Southern California Edison
ELM Project A.18-05-007

DATA REQUEST SET A1805007-ED-SCE-DEF-002

To: ENERGY DIVISION
Prepared by: Lamar Cunningham
Title: Engineering Project Manager
Dated: 08/27/2018

ELM_Q#56 M59-T2_BEFORE Example

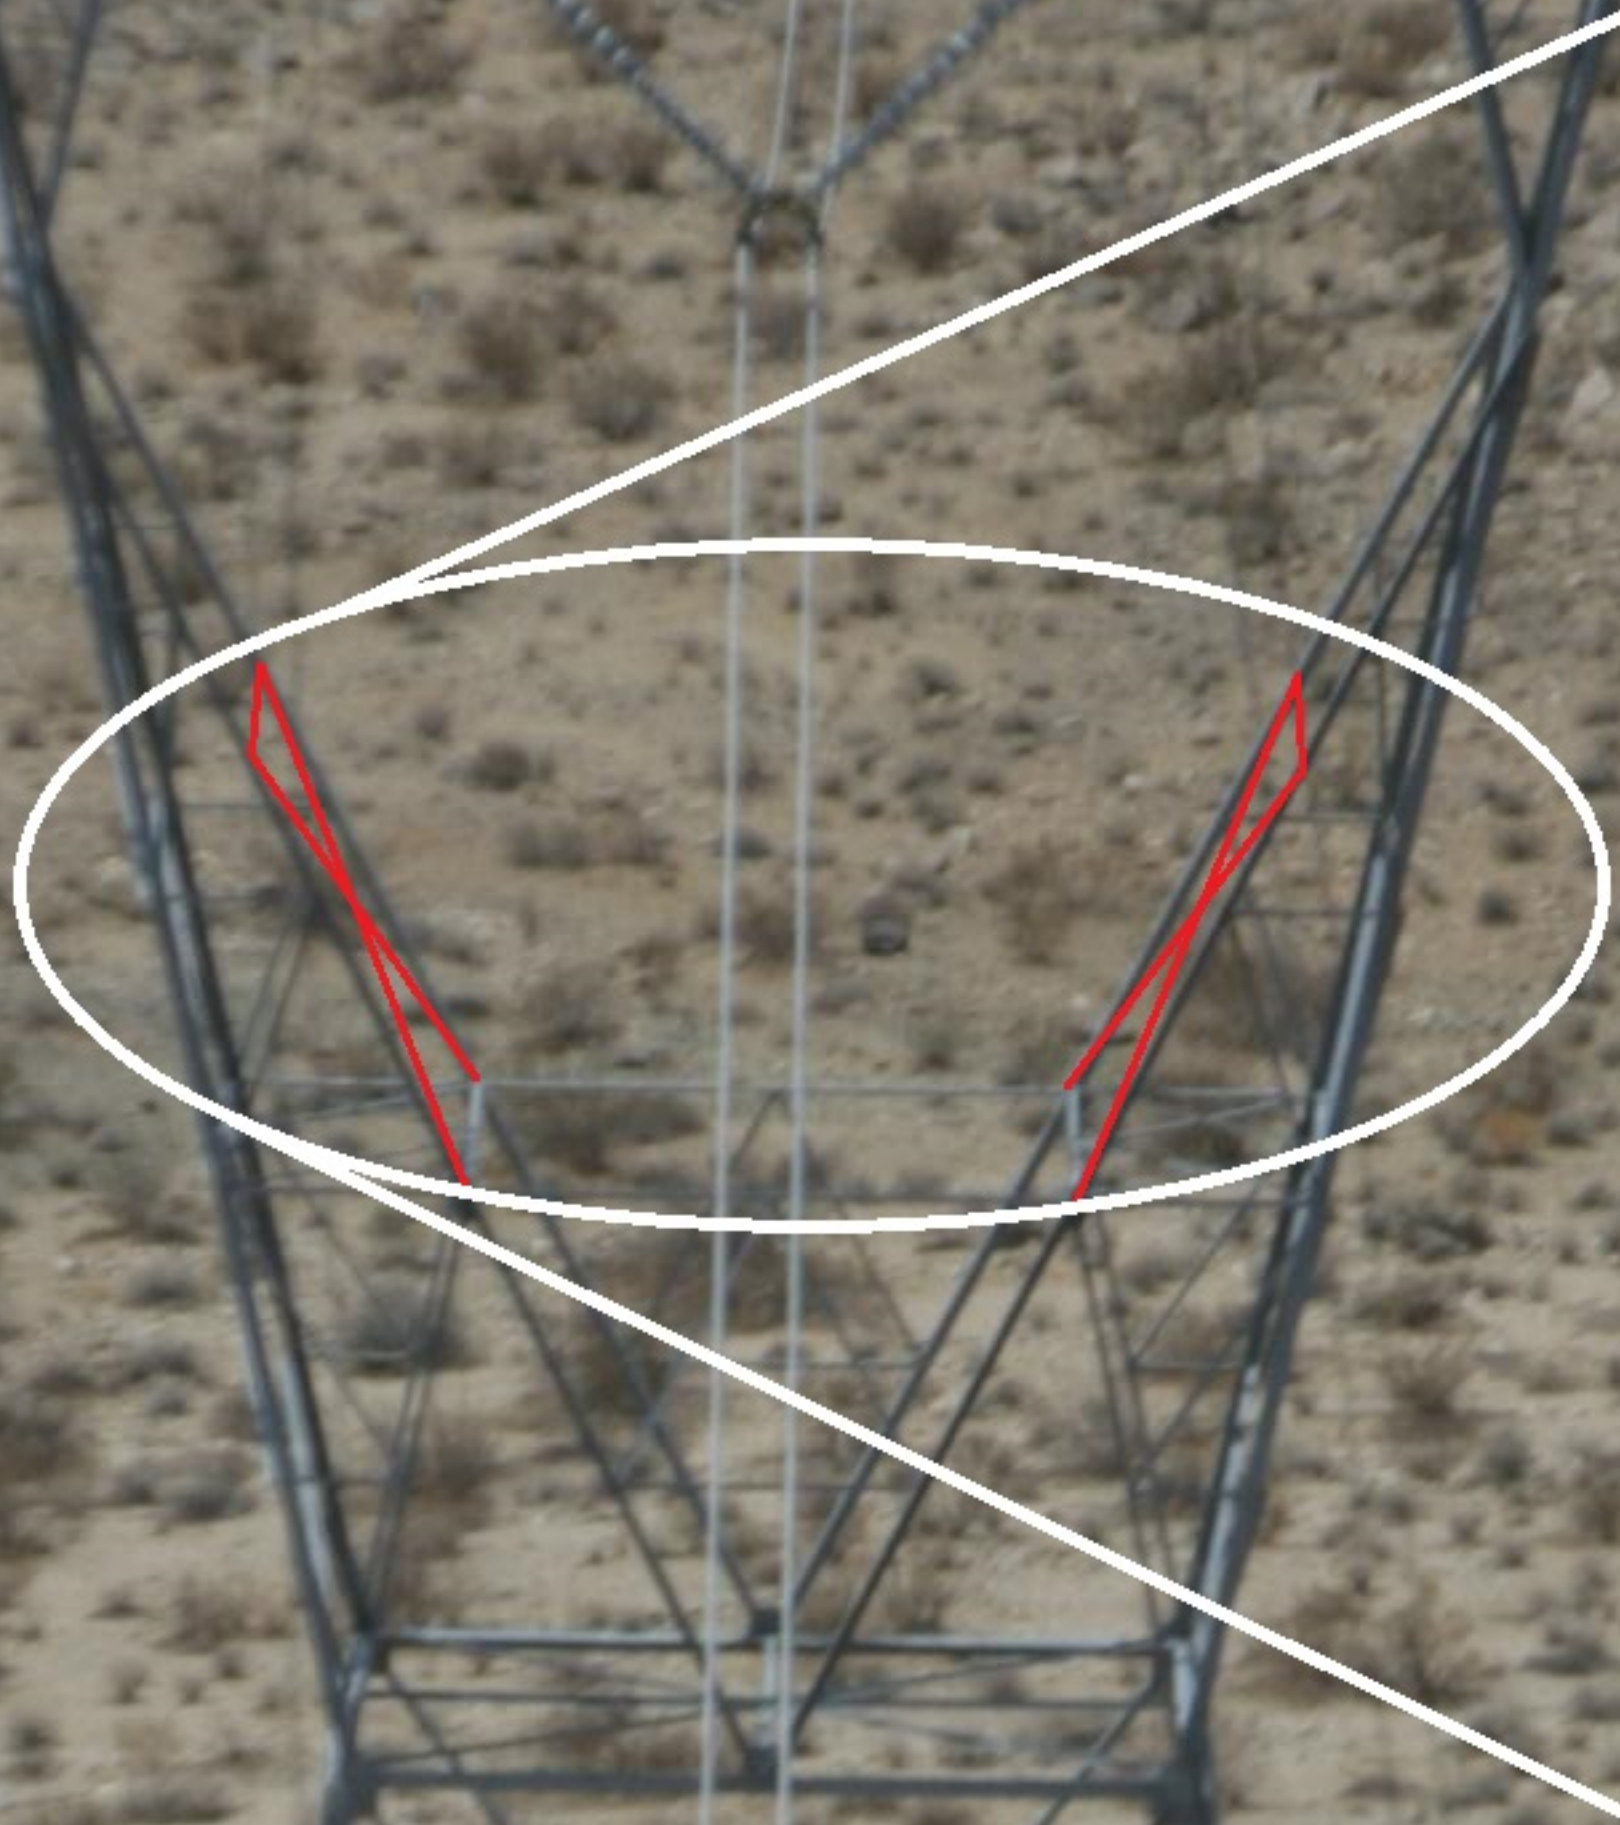
Q.56. Please provide illustrations similar to Figures 3-6 and 3-7 that show how the towers altered using these two methods would appear after construction.

Additional Steel Members added to Raise Tower

There are no special pole types or special features. Rather, SCE has decided to raise towers using tower body extensions not vertical leg extensions for this Project. Attached are before and after pictures of a recent similar tower that was raised using tower body extension method. These pictures in the attachments below show the approximate visible differences.
